General Emergency Plan update 2026

GENERAL EMERGENCY RESPONSE PLAN

LE COMMANDANT CHARCOT / VERSION 2 – APRIL 2026

New version

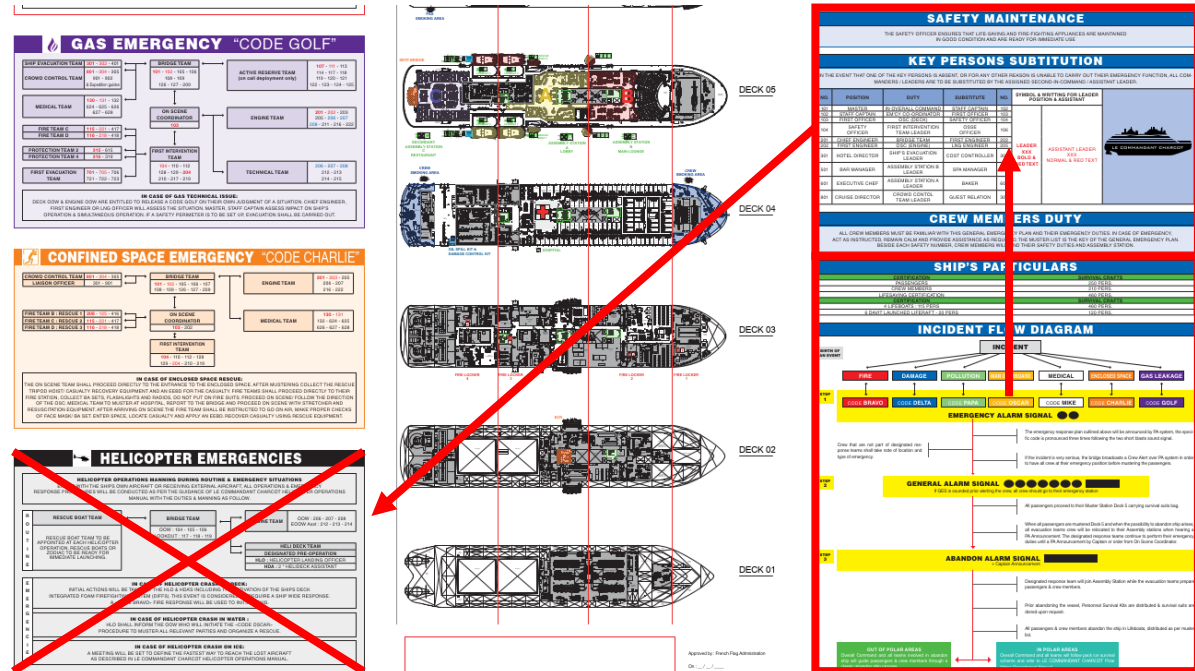
- 315 moved from LB 3 to LB 1 as per Fidelio list
- 129 moved from LB 4 to LB 3 as per Fidelio list
- 425 moved from LB 1 to LB3 as per Fidelio list
- Stars added to identify more easily the additional SN. POB detailed for better comprehension.

Notes added to explain that additional SN are not taken in account in crew member total

- Number of people at assembly station adjusted to fit with the POB
- SN 931 to 935 removed

4) Integration of Polar abandon organization diagram

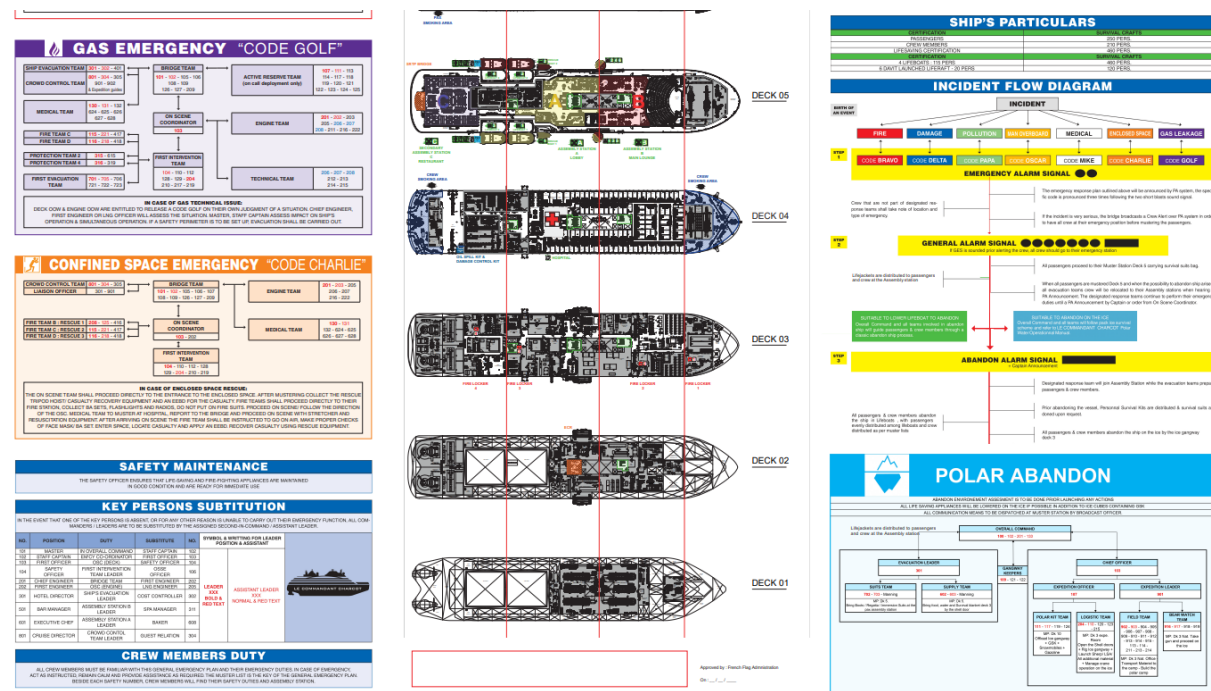
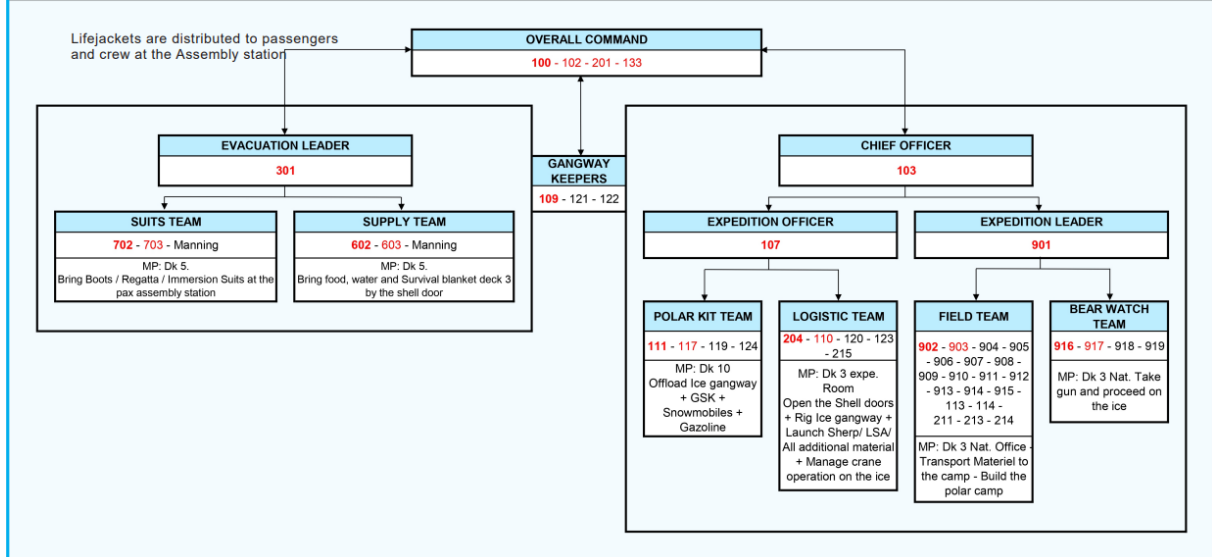
Helicopter emergencies table is deleted and replaced by safety maintenance / key personnel substitution / crew members duty.

Ship's particulars and incident flow diagram are moved up and polar abandon organization is integrated.

5) Modification of incident flow diagram

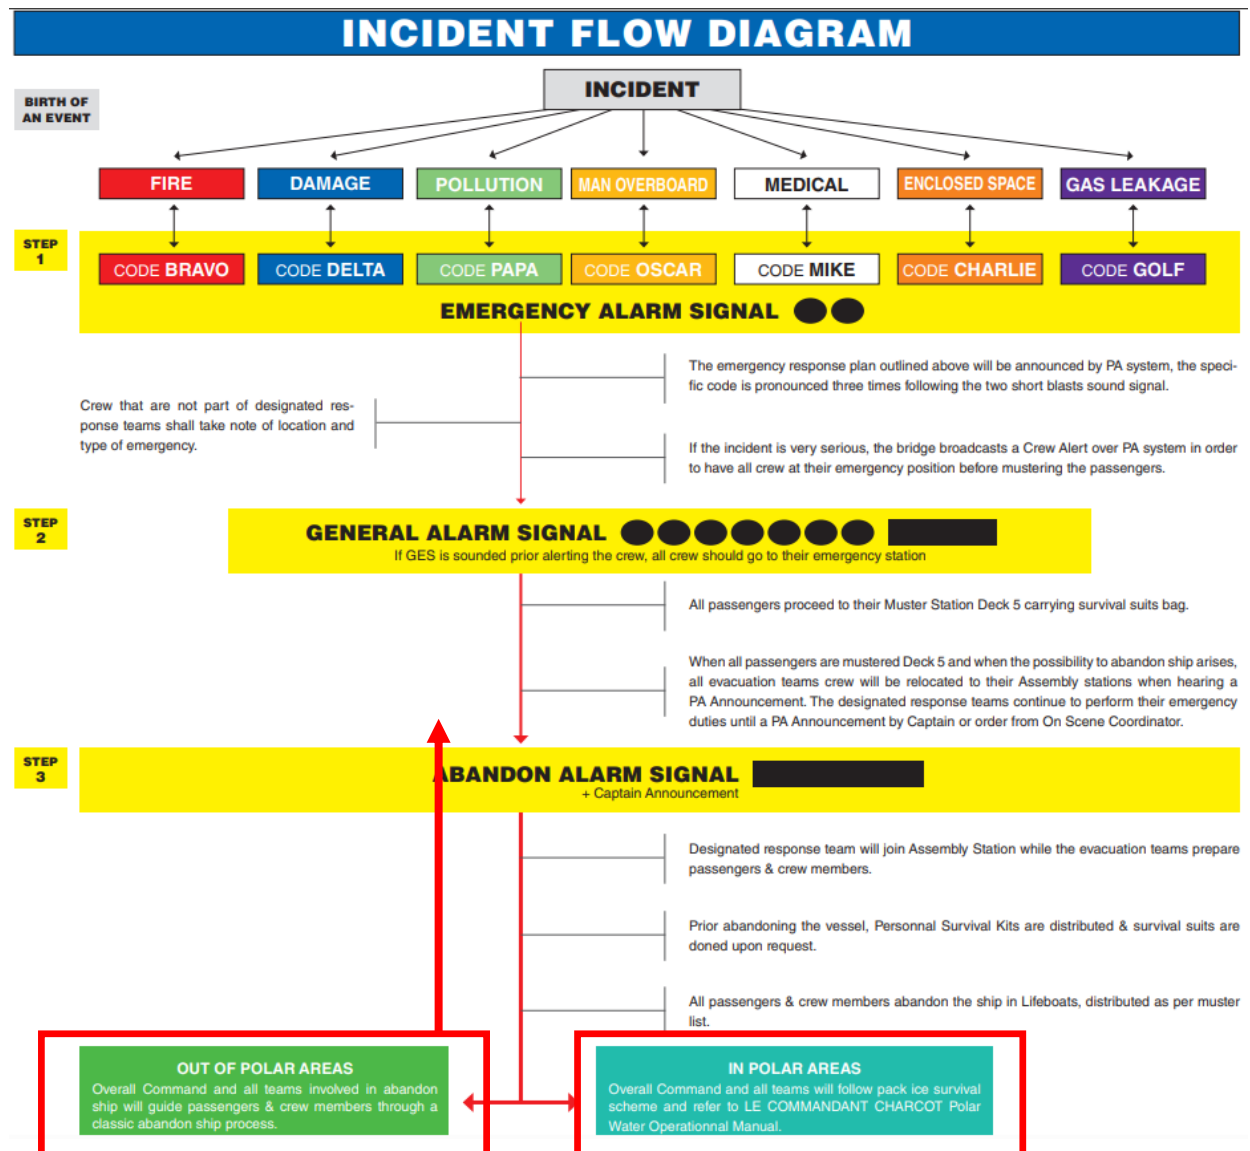
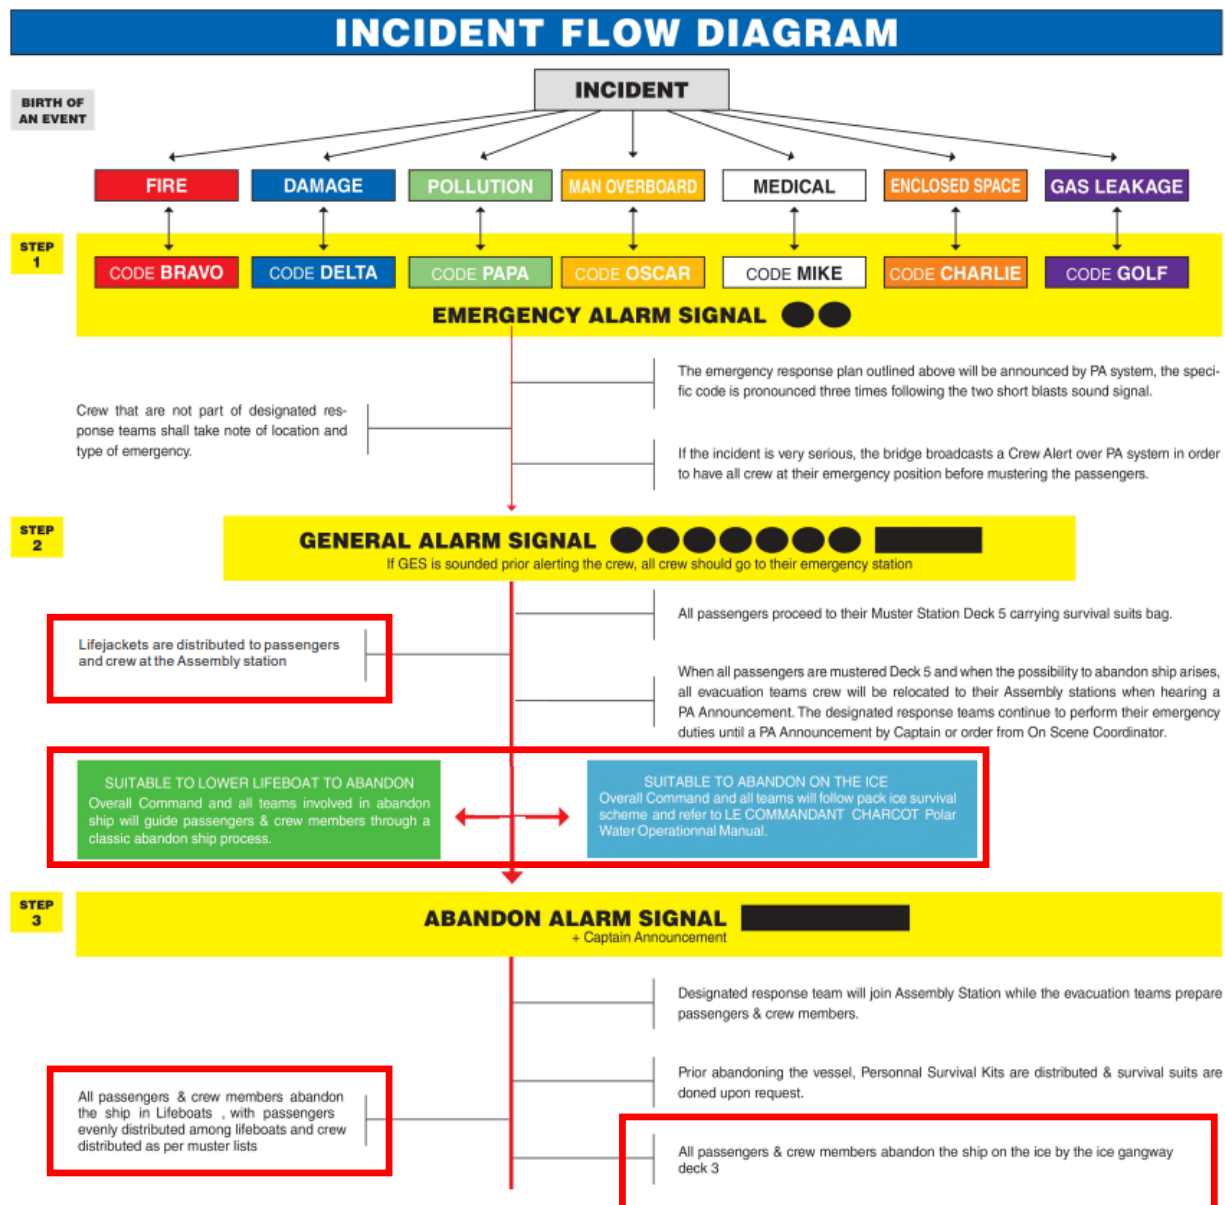
- Green & blue square “in” and “out polar waters” replaced by “suitable to lower lifeboats to abandon” and “suitable to abandon on the ice”
- The squares are moved up before Abandon ship signal as it's when the decision is taken to perform polar abandon or not
- Added text on distribution of lifejacket between GA & Abandon signal
- Added text on abandon in lifeboats or ice gangway
